Independent Technical Review

Kariong Sand and Soil Supplies Facility - Air Quality Impact Assessment

Prepared for Department of Planning, Industry and Environment
May 2021

J210264 RP1

Figure 2.1 Diurnal variation of calm conditions – BoM Gosford AWS – 2013 to 2020

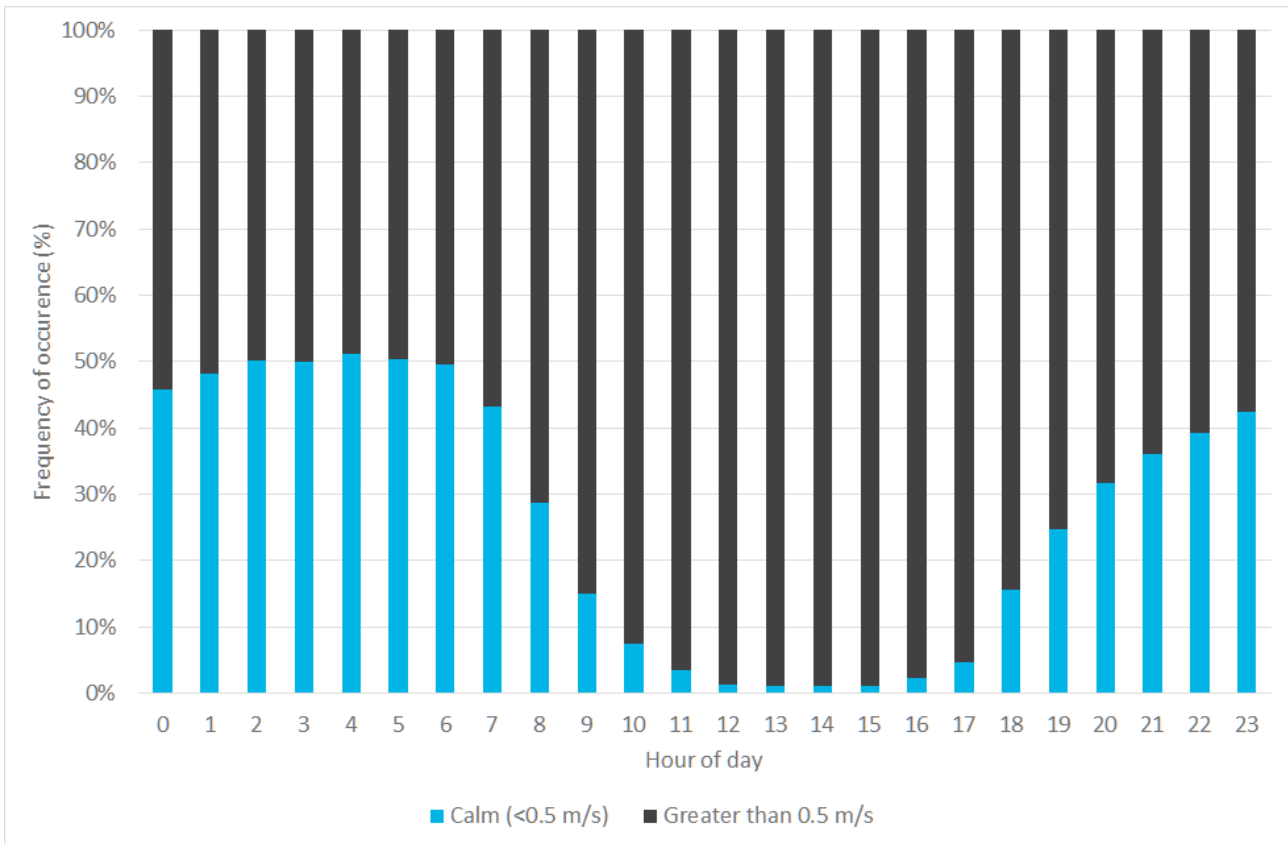
It is, however, EMM’s view that the issue relating to low wind conditions is overstated by TAS. Hourly average wind speed data from the BoM Gosford station recorded between 2013 and 2020 was reviewed and percentage of calm conditions by hour of the day was calculated. As stated in the Northstar addendum AQIA, emissions were modelled between the hours of 7.00 am and 5.00 pm for the delivery of waste materials and product sales and 8.00 am and 5.00 pm for the processing of waste. As shown in Figure 2.1, the percentage of calm winds decreases significantly during the day. The periods of highest calm winds occur outside the modelled operating hours of the proposed Facility. Consequently, the influence of calm winds on model prediction are unlikely to be as significant as inferred by the TAS review.
